Our Ref: MT/6096

19th February 2026

Re: Interbridges Site, New Brighton Road, Emsworth (LPA ref. APP/24/01010)

Bellamy Roberts has been instructed by PNH Properties to provide a written response to the LLFA's consultation comments dated 23rd June 2025, which are enclosed for reference.

Figure 1: Baseline Modelled Flood Extents (Source: Aegaea)

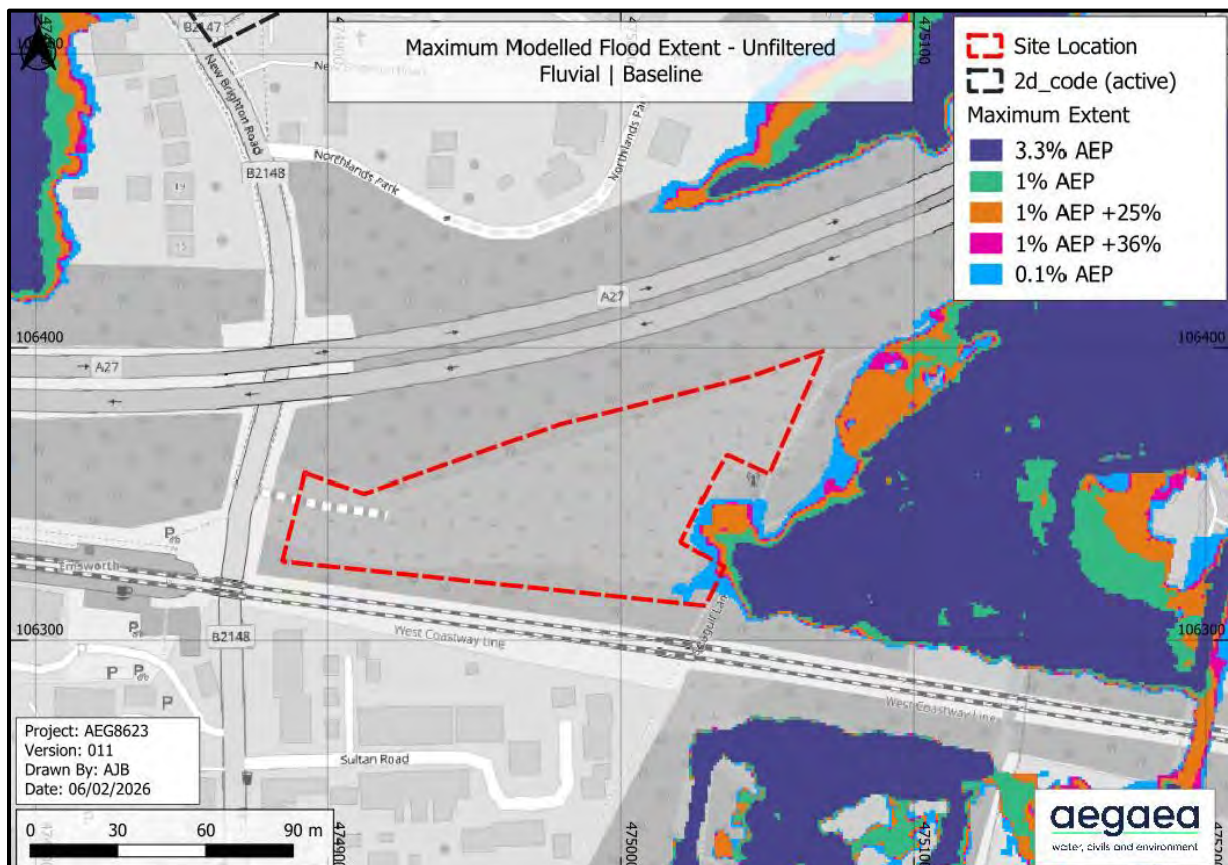
The Flood Risk mapping has been updated to reflect the latest Environment Agency data. The updated fluvial flood risk maps have been overlaid on a site plan in appendix 8 of the above updated flood risk assessment. This shows that part of Block A, the whole of Block B, and significant areas of service yard / parking areas / access road are all located in identified areas of flood risk. As explained in our previous comments, development should be located outside of areas of flood risk and if development is proposed in these areas, flood compensation areas will be required and details on how the topography will be altered to ensure new development is not at risk. Modelling may also be required to support this. As the identified flood risk is from rivers, the Environment Agency will be able to provide further advice.

The proposed attenuation tank is also partially within the area of fluvial flood risk and fully below the peak flood level. Our understanding is that in the event of a river flood the surface water drainage network would be inundated and would not function. In this event without a functioning surface water drainage system, the discharge from the site would exceed the existing greenfield runoff rate and the downstream flood risk would be increased.

In summary, the hydraulic model outputs show that the site remains largely outside the extent of all simulated rainfall events.

The site is identified as being outside the 1% AEP maximum flood extent which is analogous to Flood Zone 3 in lieu of historic or tidal flood extents. Minor encroachments to the site boundary are noted for the 1% AEP + 25% climate change, 1% AEP + 36% climate change and 0.1% AEP events, however the flooding is confined to the lowest ground elevations on site in the very southeast corner of the site.

Figure 1 shows the baseline maximum modelled flood extents.

The Aegaea modelling results demonstrate that the only area of the site affected by future flood risk is the south-eastern corner of Yard B and this is only during the 0.1% AEP event. No other areas of the site are located in areas at risk of flooding.

The depth of flooding in this part of the site is primarily less than 100mm.

The proposed surface water drainage system will therefore not become inundated and would continue to function.
